STATE OF HAWAII
DEPARTMENT OF TRANSPORTATION
HIGHWAYS DIVISION
UTILITY PLAN
MAUNA KEA MAINTENANCE
BASEYARD
DANIEL K. INOUE HIGHWAY
Project No. 200A-01-10
Scale: As Shown Date: April, 2018

1	06-07-18	ADDENDUM NO. 4	
REVISION	DATE	DESCRIPTION	AA15

STATE OF HAWAII
DEPARTMENT OF TRANSPORTATION
HIGHWAYS DIVISION
SHOP BUILDING
MAUNA KEA MAINTENANCE BASEYARD
DANIEL K. INOUE HIGHWAY
Project No. 200A-01-10

Notes:

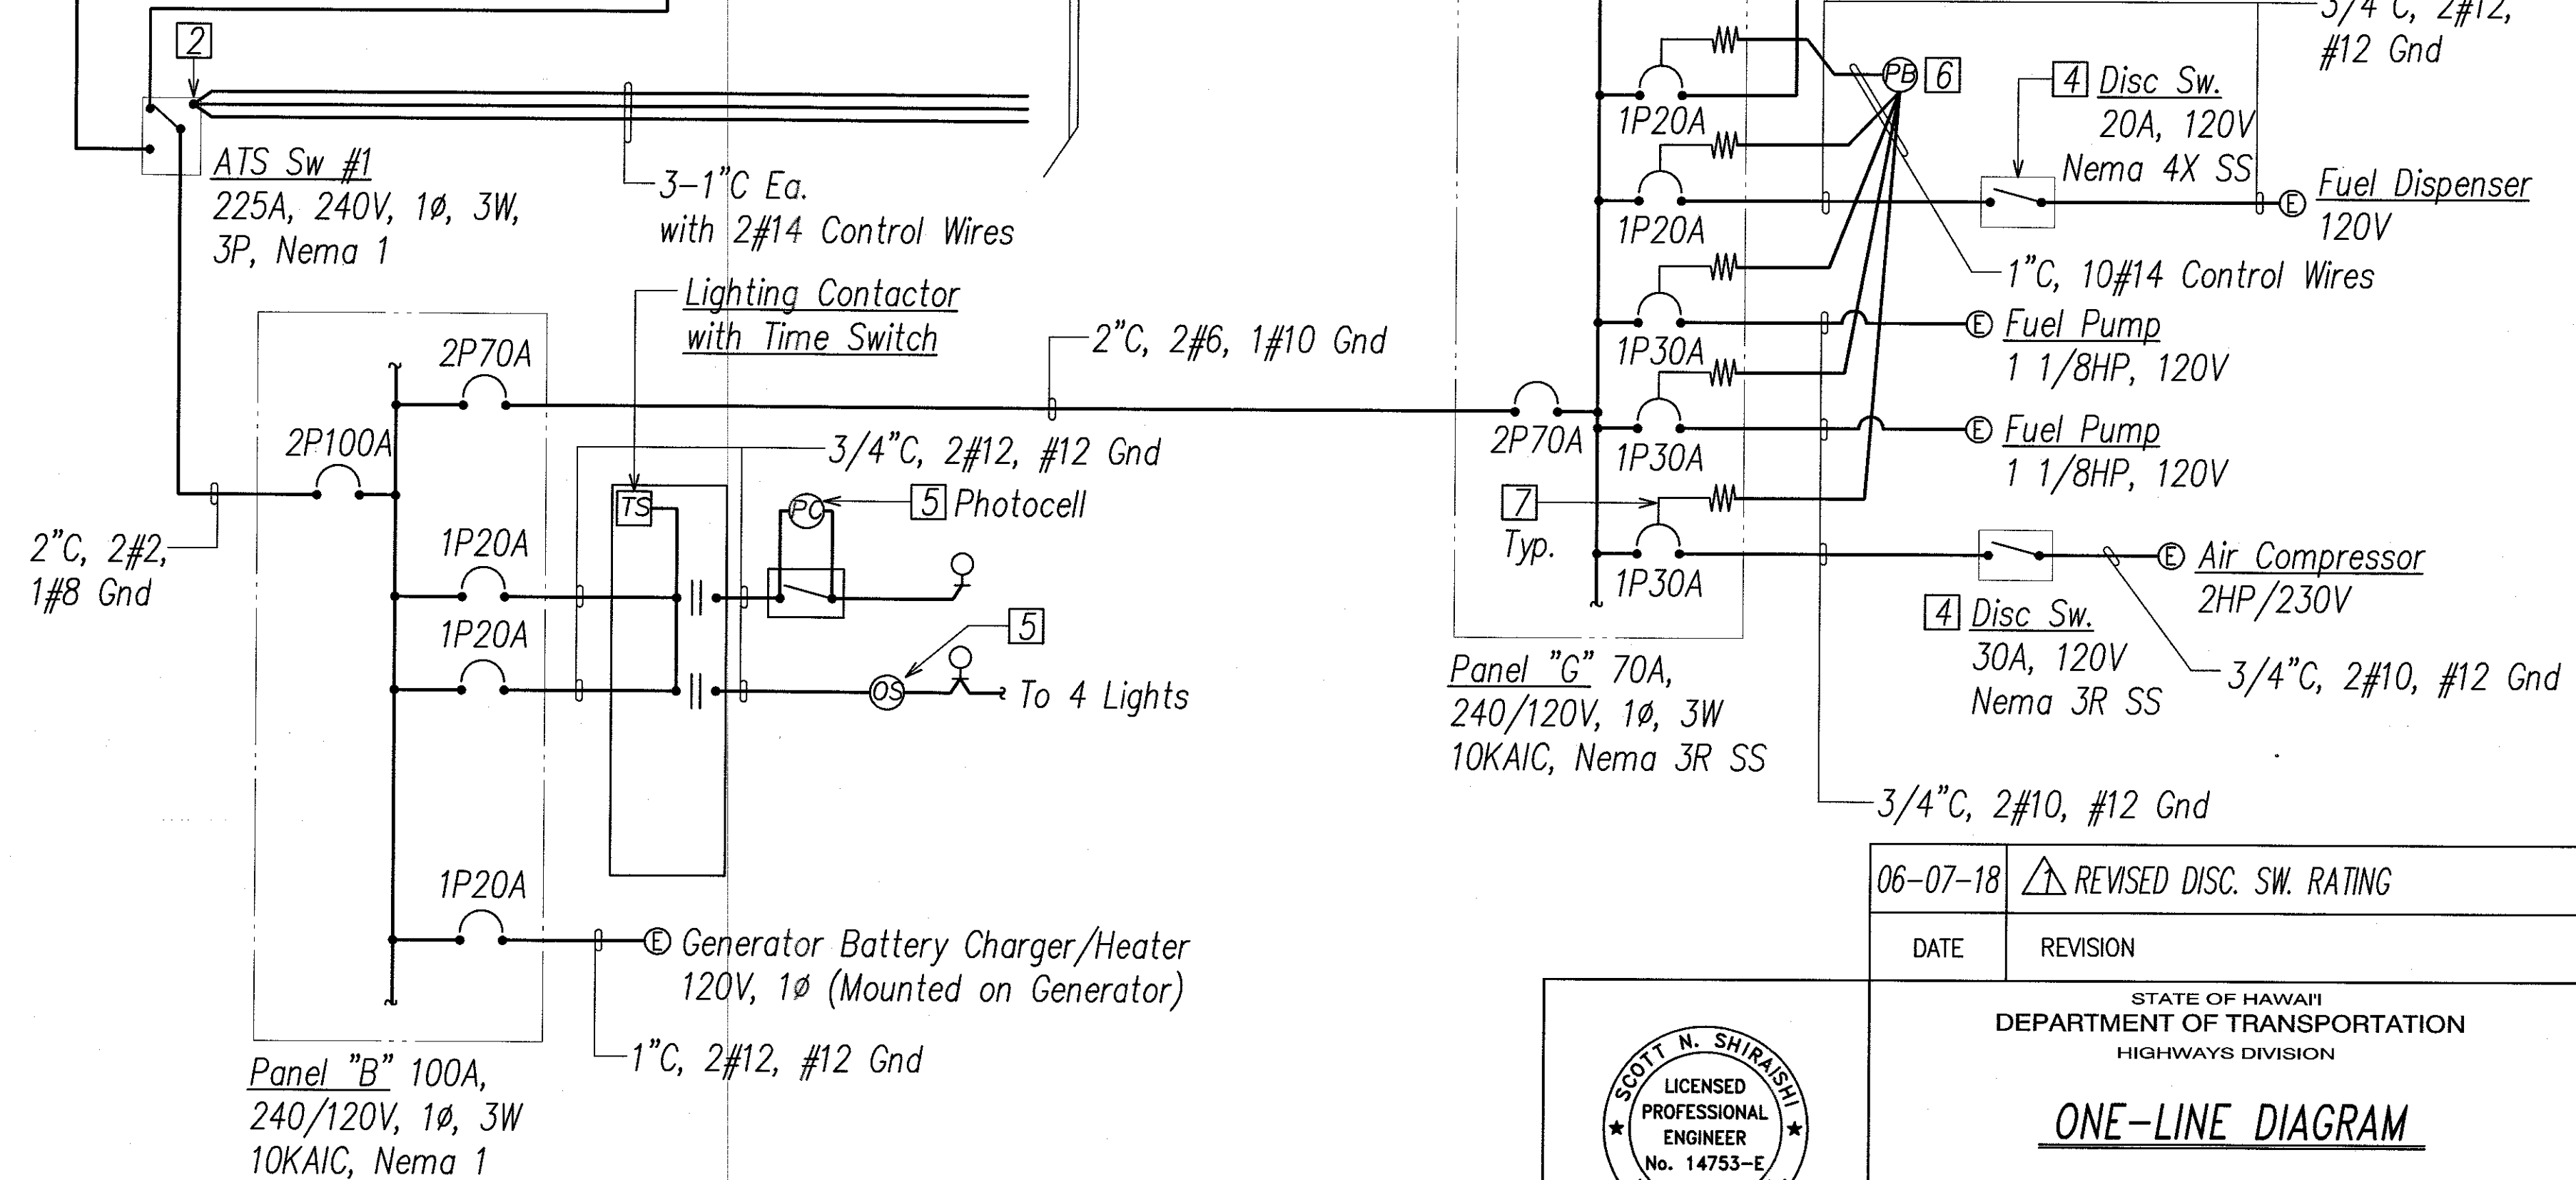
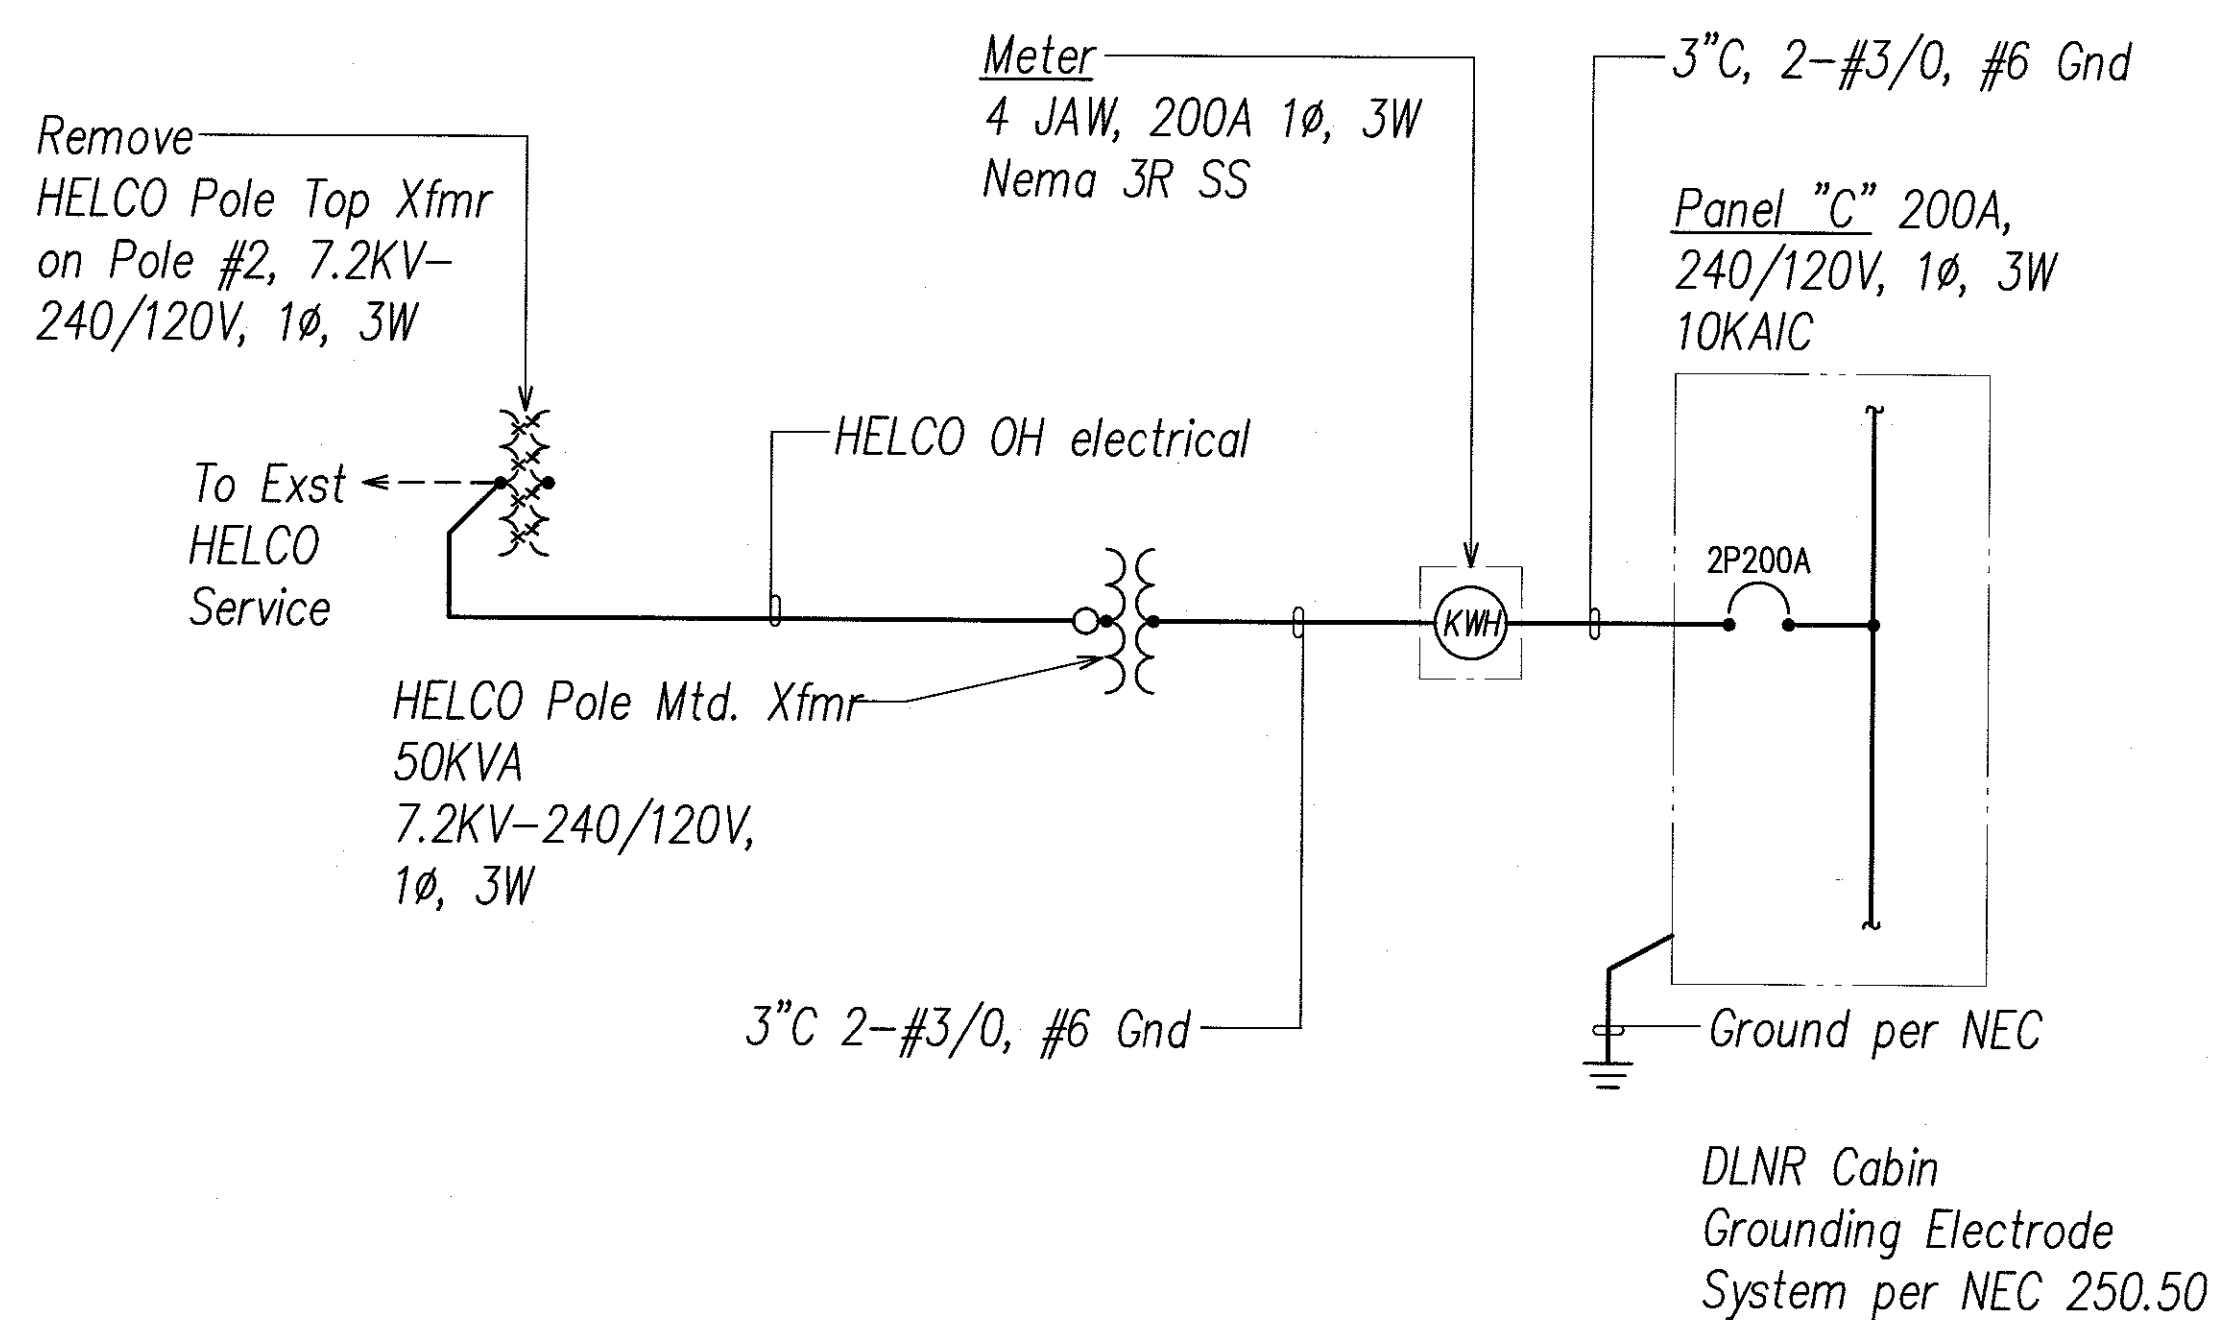
06-07-18	 REVISED DISC. SW. RATING
DATE	REVISION

E2.06

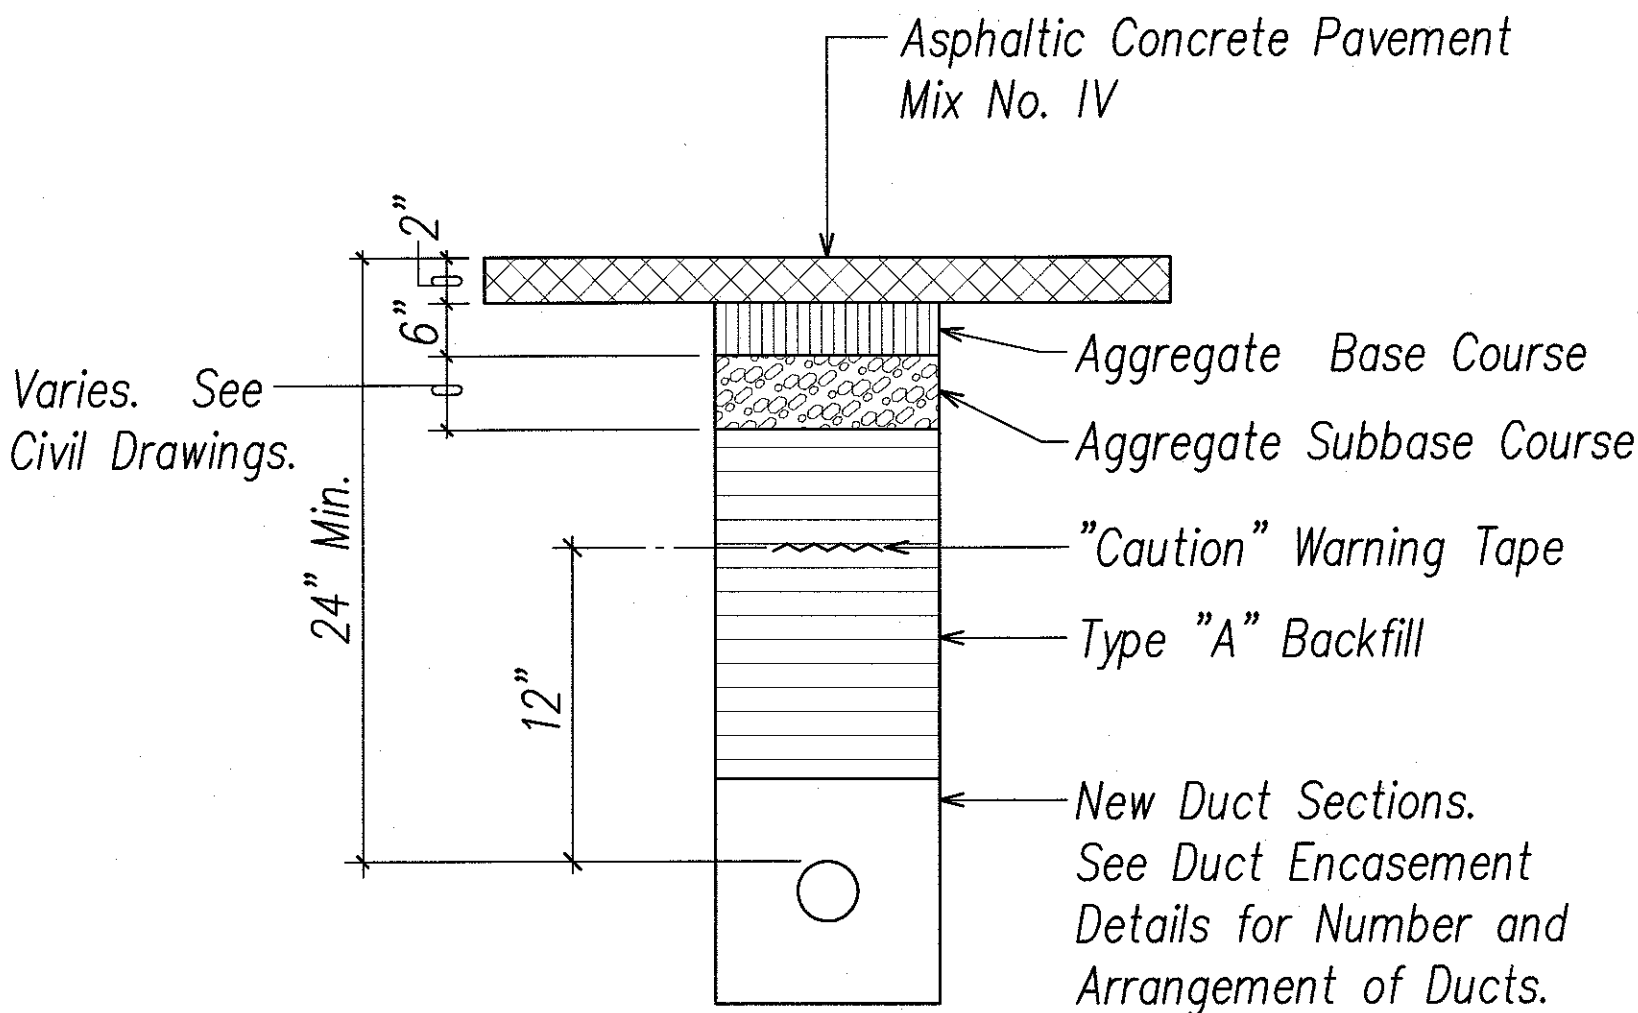
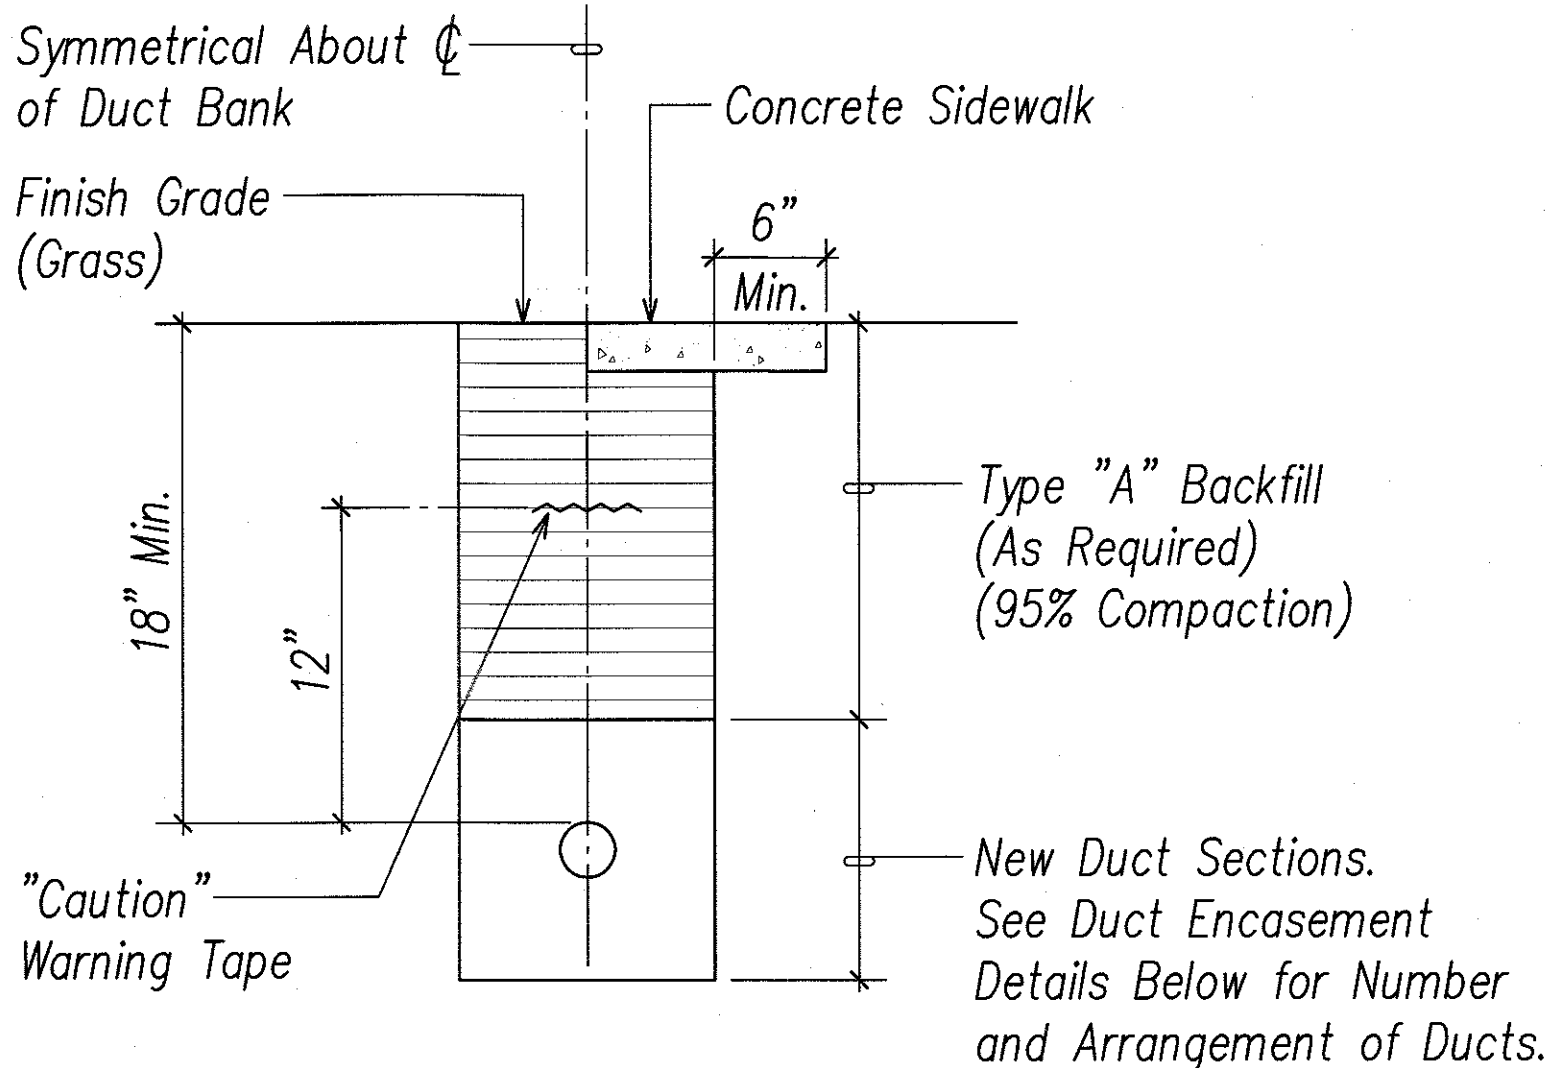
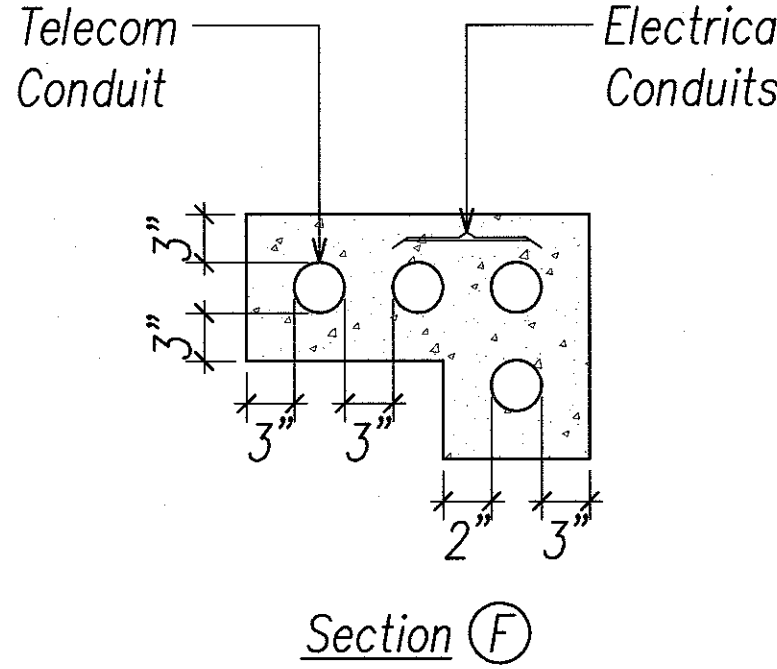
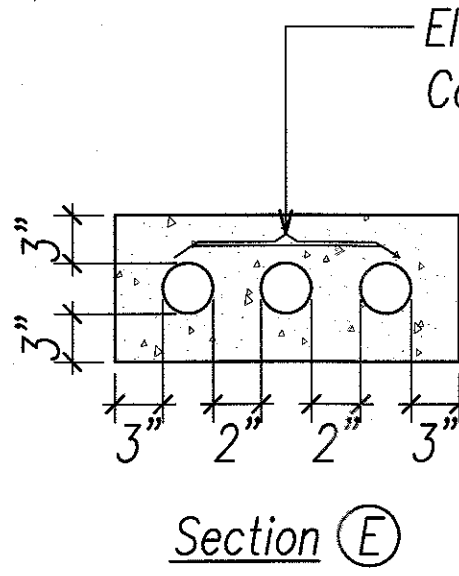
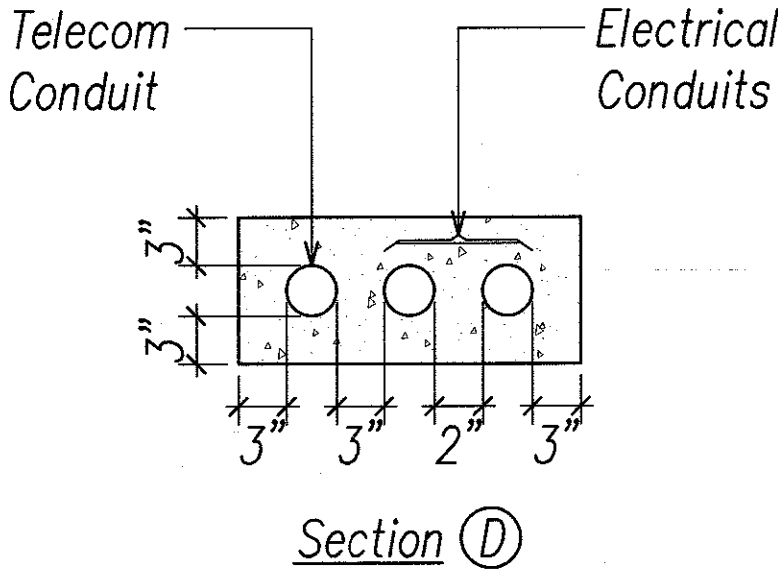
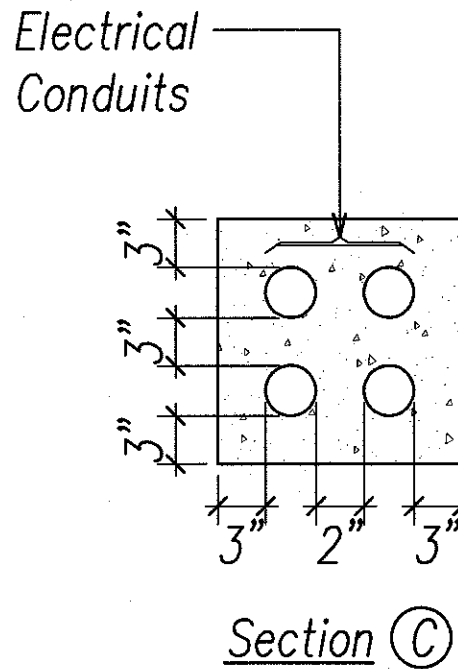
06-07-18	△ ADDED TELECOM DUCTLINES
DATE	REVISION
STATE OF HAWAII DEPARTMENT OF TRANSPORTATION HIGHWAYS DIVISION	
DETAILS & DUCT SECTIONS	
MAUNA KEA MAINTENANCE BASEYARD DANIEL K. INOUE HIGHWAY Project No. 200A-01-10	
Scale: As Noted	Date: APRIL, 2018
